UNITED STATES PATENT AND TRADEMARK OFFICE

Office Action Summary	Application No. 10/826,400	Applicant(s) SUDANO ET AL.	
	Examiner Raymond Alejandro	Art Unit 1745

DETAILED ACTION

FIG. 6

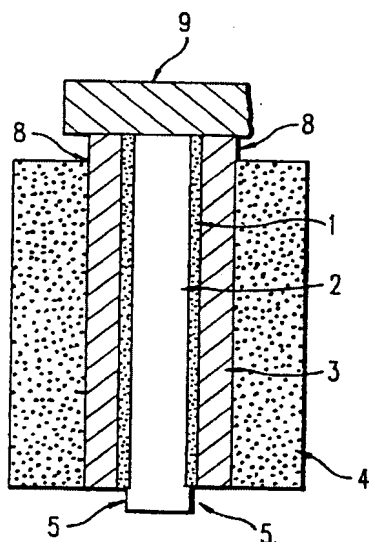
Figure 6 of Gauthier et al is the basis for the anticipation analysis.

Gauthier et al teach electrical contacts 9, 10 (COL 9, lines 44-50) which consists of metal added at the lateral ends of the assembly once the assembly is stacked in its final form (COL 6, lines 40-45).

Figure 6 below shows insulating plastic support film 2 which is a polymeric synthetic resin (COL 3, lines 55-60/ COL 4, lines 41-60/ COL 9, lines 29-32/EXAMPLE 1); metallic films 1 and metallic deposit 3 on both sides of the support film 2 (COL 3, lines 55-60/ COL 4, lines 10-27/COL 9, lines 21-35/Example 1); and electrode layers 4 (COL 9, lines 33-36/EXAMPLE 1). Reference numeral 8 is the conductive lateral margin of the current collector; and reference numeral 5 is the lateral margin of the plastic support film. Gauthier et al disclose that collectors can be made from at least Sn (COL 2, lines 12-15). *In this case, the electrical contact 9 is defining a space itself in which the ends of the current collector (i.e. the metal-coated support film constituted by reference numerals 1-2-3) are received, and a ductile electrically conductive*

material (namely, Sn) is part of the electrical contact itself and is adapted to form an electrical connection therebetween.

In this case, the electrical contact 9 is defining a space itself in which the ends of the current collector (i.e. the metal-coated support film constituted by reference numerals 1-2-3) are received and crimped, and a ductile electrically conductive material (namely, Sn) is part of the electrical contact itself and is adapted to form an electrical connection therebetween. See FIGURE 6. It is noted that the term "crimp" means "to form into a desired form" or "to pinch or press together" as per Merriam-Webster's Collegiate Dictionary (10th Edition). Thus,

portions of the electrical contact 9 crimps onto the ends of the current collector constituted by the metal-coated support film constituted by reference numerals 1-2-3.

Fig. 2

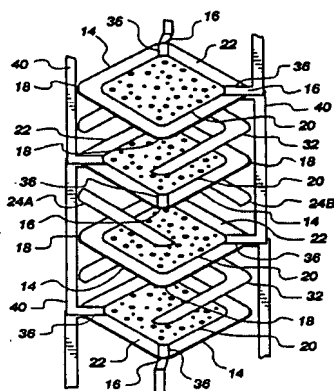
Nachles et al disclose an electrically conductive material 40 (*the electrical contact*) which is in electrical contact with the interconnect strips 36 (*the current collecting elements*) on the underside of the top electrolyte plate 14 (COL 7, lines 29-48). A plurality of solid electrolyte plates arranged into a stack, each electrolyte plate having electrode material adherent thereto is disclosed (ABSTRACT). A metal such as Ag, Ag-alloy or Pt is used as the electrically conductive material (COL 5, lines 33-45)

In this case, the electrically conductive material 40 itself defines a space in which the ends of the interconnect strips 36 are received and crimped; and the electrically conductive material itself represents the ductile material forming the electrical bridge. Note that a metal such as Ag, Ag-alloy or Pt is used as the electrically conductive material (COL 5, lines 33-45). Notice also that the degree of ductility is unknown, thus, the foregoing metallic materials are capable of being fashioned or changed into a new form.

In this case, the electrically conductive material 40 itself defines a space in which the ends of the interconnect strips 36 are received and crimped; and the electrically conductive material itself represents the ductile material forming the electrical bridge. See FIGURE 2. It is noted that the term "crimp" means "to form into a desired form" or "to pinch or press together" as per Merriam-Webster's Collegiate Dictionary (10th Edition). Thus, portions of the electrical contact 40 crimps onto the ends of the interconnect strips 36.
